Project AC-NH-060-BC 002)  
H513701C  
Grand Avenue (US-60)  
27<sup>TH</sup> avenue/Thomas Road

## **Final Environmental Assessment**

### **GRAND AVENUE (US 60) 27<sup>TH</sup> AVENUE/THOMAS ROAD**

### **III. ERRATA FROM THE DRAFT ENVIRONMENTAL ASSESSMENT**

Figure 9. Alternative 6: 27th Avenue Ramps (eliminated)

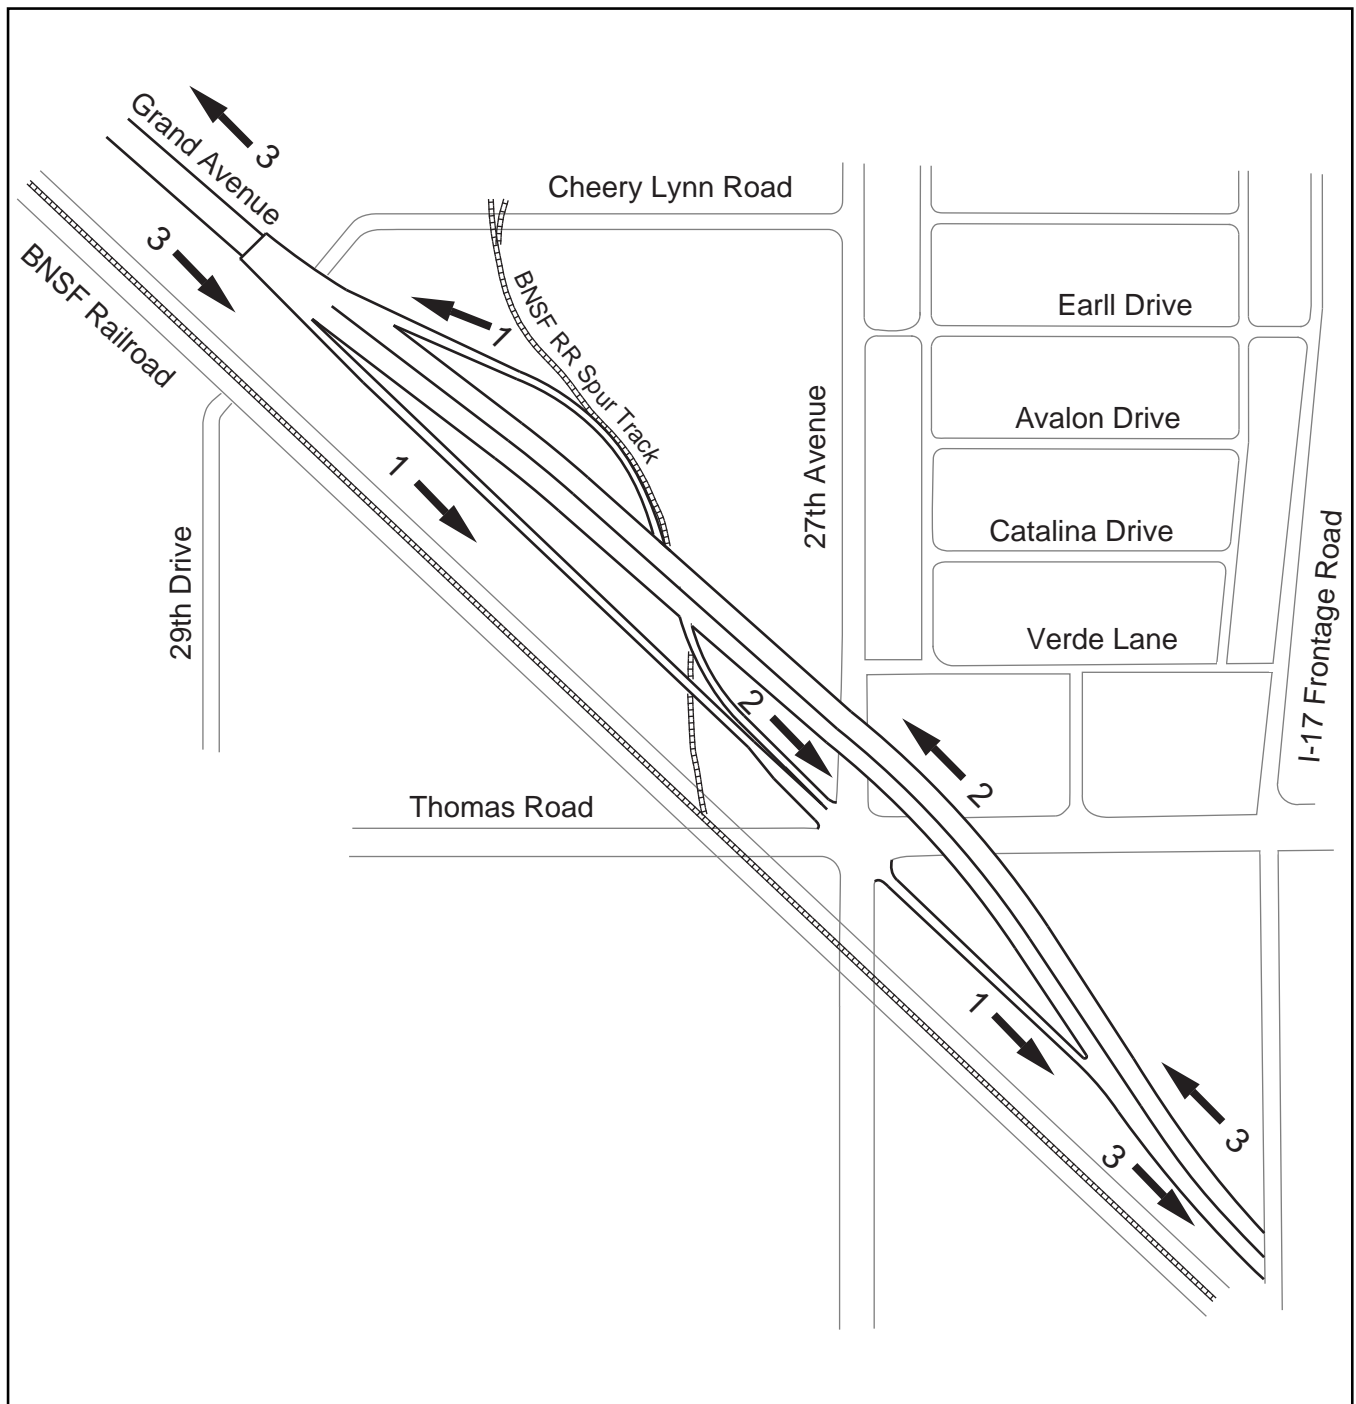
Verde Lane west of 26<sup>th</sup> Avenue has been revised to connect to the Interstate 17 (I-17) frontage road. (Refer to pages 7-12 of this document.)

Figure 11. Alternative 8: Grand Avenue Overpass (preferred alternative)

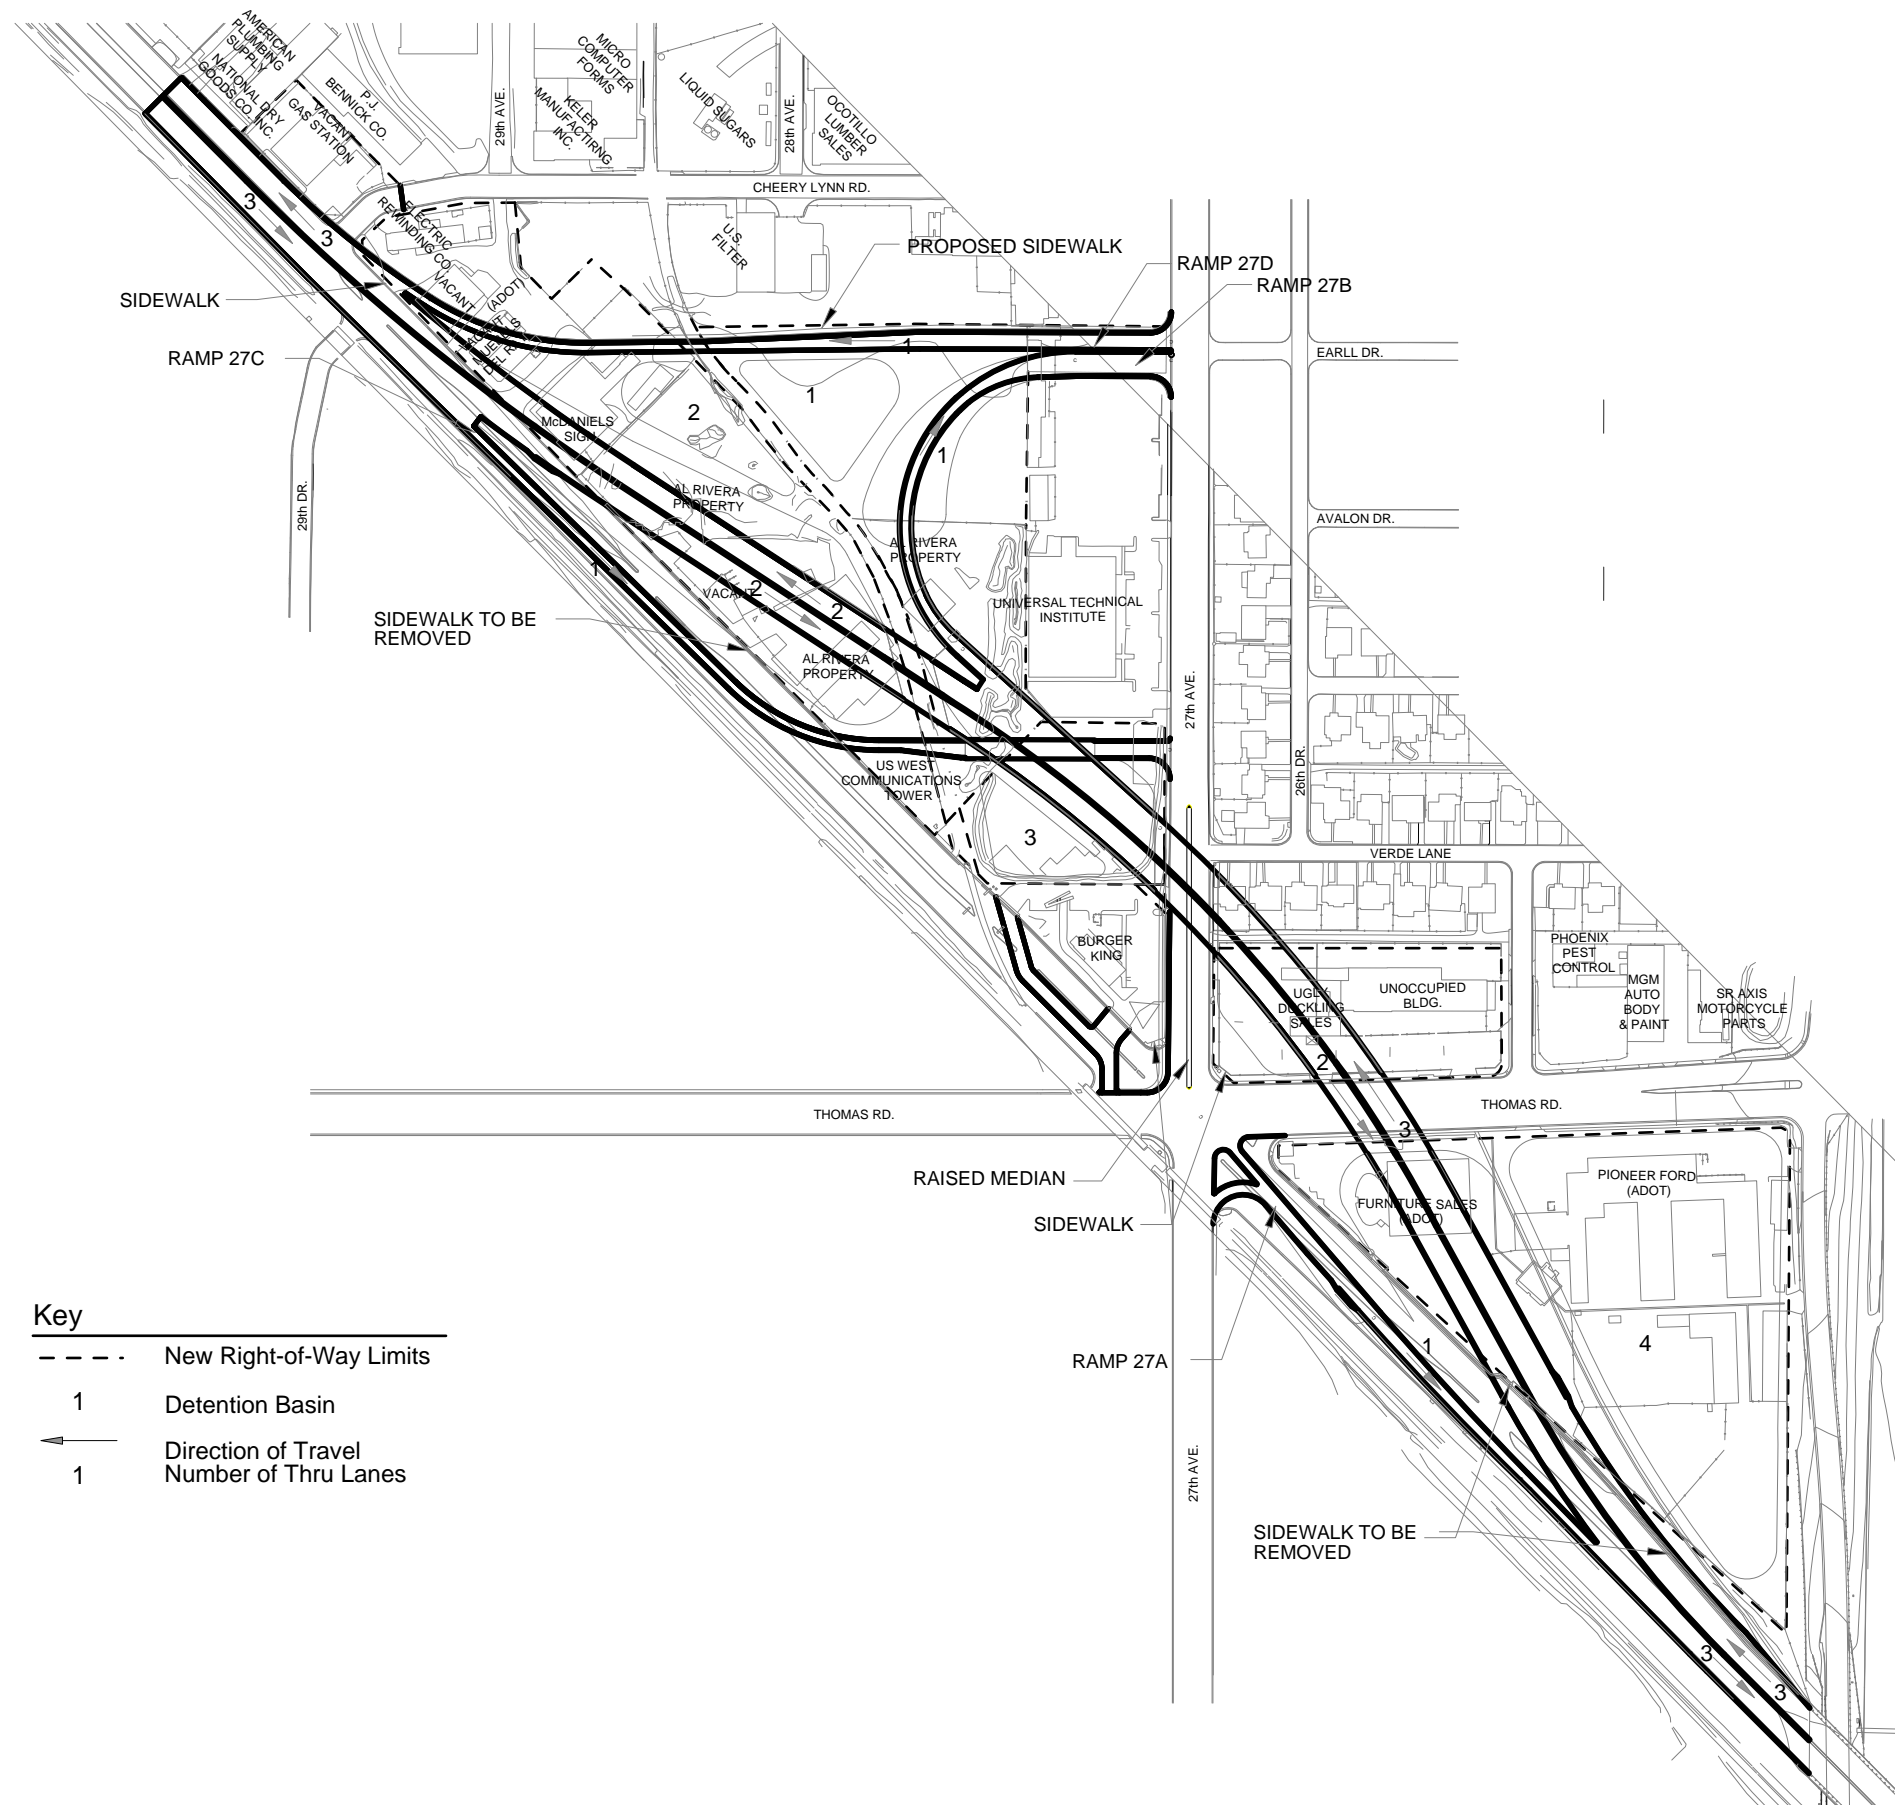
ADOT has identified Alternative 8 from the DEA as the selected alternative. Based on comments received from local jurisdictions and the general public, minor changes have been made to the selected alternative. ADOT will add a raised median between north and southbound traffic lanes on 27<sup>th</sup> Avenue to prevent left-turn movements onto Verde Lane. In addition, the westbound right turn lane from Thomas Road to 27<sup>th</sup> Avenue will be extended to provide additional storage capacity for motorists seeking this turning movement. No other substantial modifications have occurred since the selected alternative was presented in the DEA.

#### Figure 12. UTI and Burger King Parking Relocation Details (DEA page 19.)

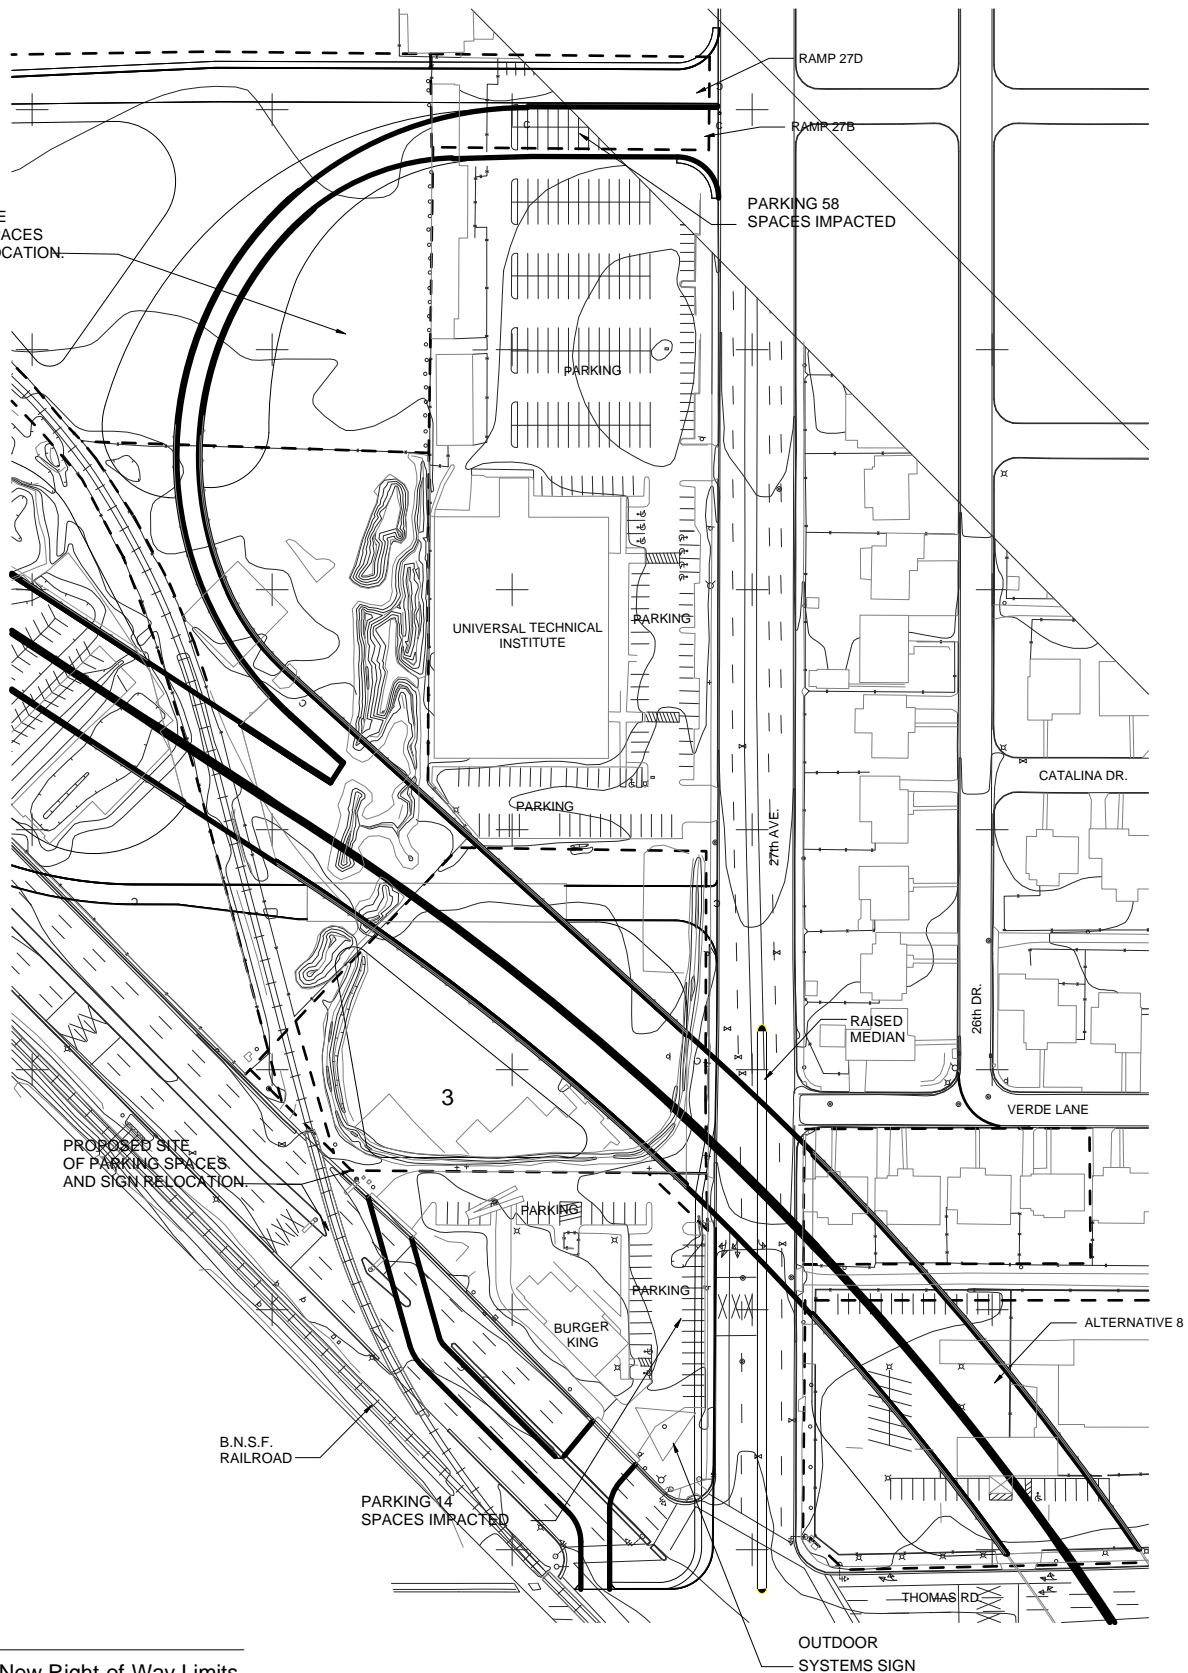
Verde Lane will not be closed west of 26<sup>th</sup> Drive. In addition, the right-of-way line from the alley directly south of the residences includes a full take of four residences. (Refer to page 15 of this document.)
